SEWAGE DISPOSAL SYSTEM

MARYLAND STATE DEPARTMENT OF HEALTH\*

Jack Gottlieb, Golden Key Homes, Inc. IS PERMITTED TO INSTALL  ALTER

ADDRESS Annapolis Junction Road, Annapolis Junction, Md. PHONE 792-7850

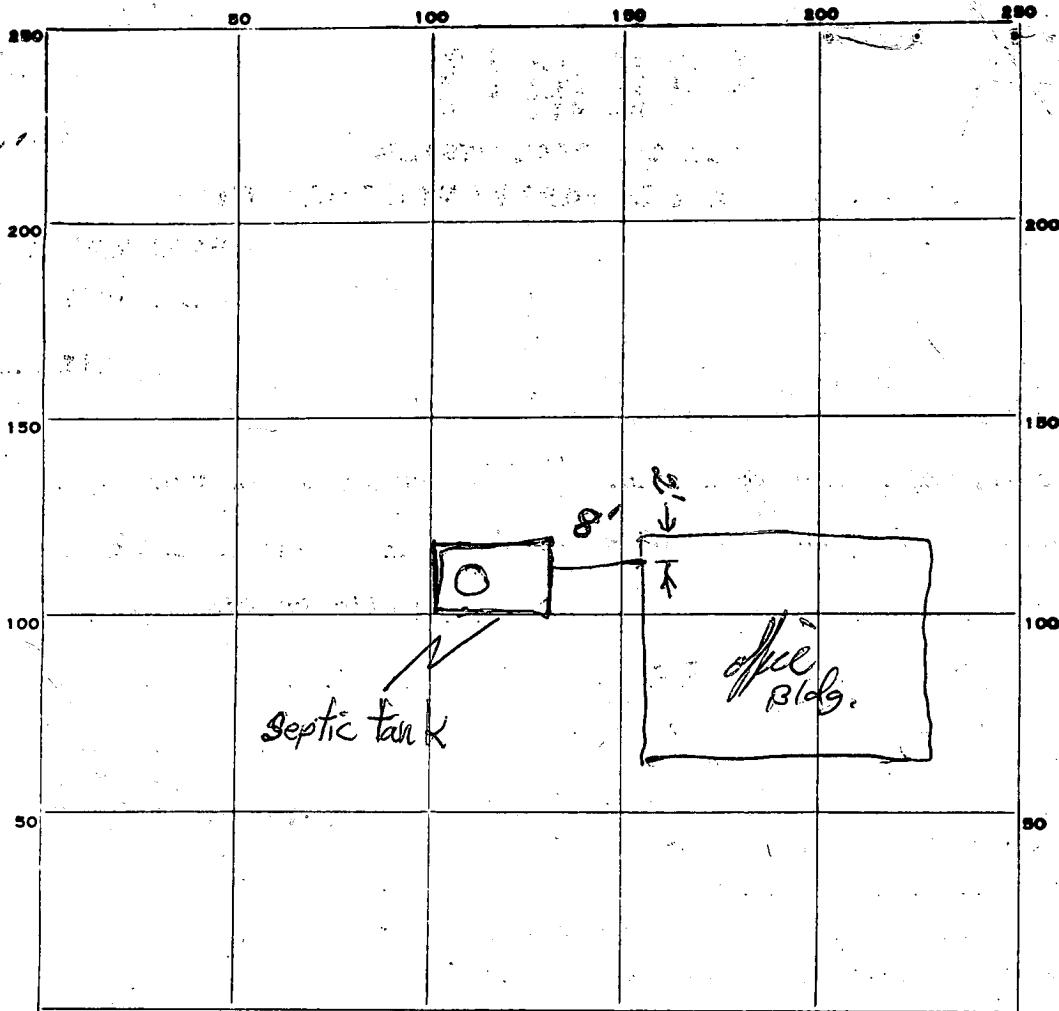
REMARKS either dig out deeper to depth of 20 ft or more. if this is sat. c/f system - if not sealed tank with alarm

TYPE OF SOIL ~~either~~ Either install system deeper than 14' or holding tank with alarm

**INSTALL 1500 GALLON SEALED TANK - PARGED INSIDE AND OUTSIDE WITH ALARM DEVICE.**

**OLD SYSTEM MUST BE COMPLETELY ABANDONED AND FILLED IN. CONTRACT WITH SCAVENGER**

**MUST BE PROVIDED.**

RE: F-85-17 Golden Key

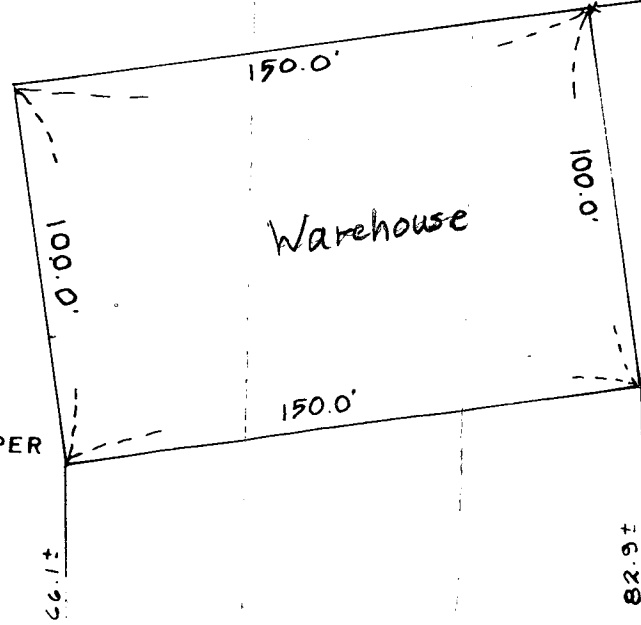
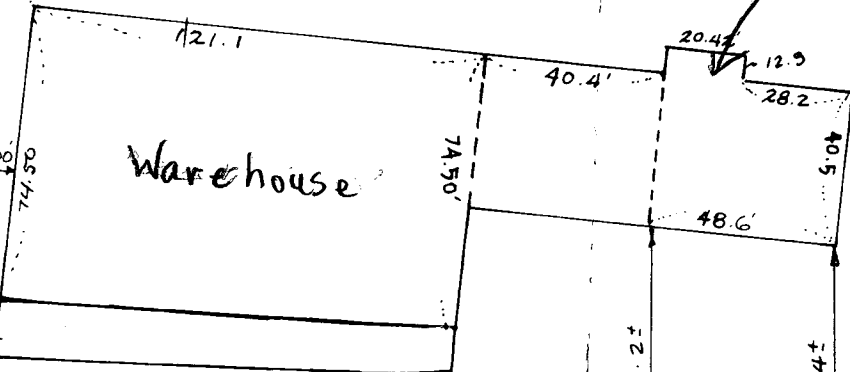
OTHER COMMENTS: Soil Survey indicates most of site has been filled. If enough suitable soil is found outside of filled area, percolation tests may be performed in virgin soil only.
